Notice 95-001

Relief Valve Stem

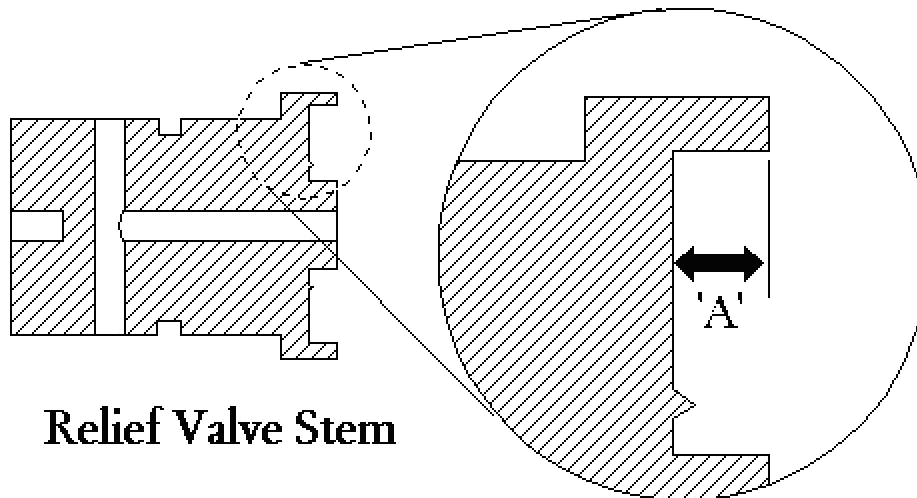
Since that time the manufacturer has made modifications to the disc retaining cup in the relief valve stem (Dwg #9711-5) which allows the assemblies to pass the laboratory evaluation. Therefore, the Wilkins Model 975 8" and 10" reduced pressure principle backflow prevention assemblies appear on the 1 March 1995 List of Approved Backflow Prevention Assemblies with the stipulation that only those assemblies bearing serial number of B09745 and later are Approved. Assemblies bearing an earlier serial number may be brought up to the required Specifications by replacing the relief valve stem with the new relief valve stem replacement. The differences are detailed below.

Dimension 'A' has been changed from 0.175" to 0.200"
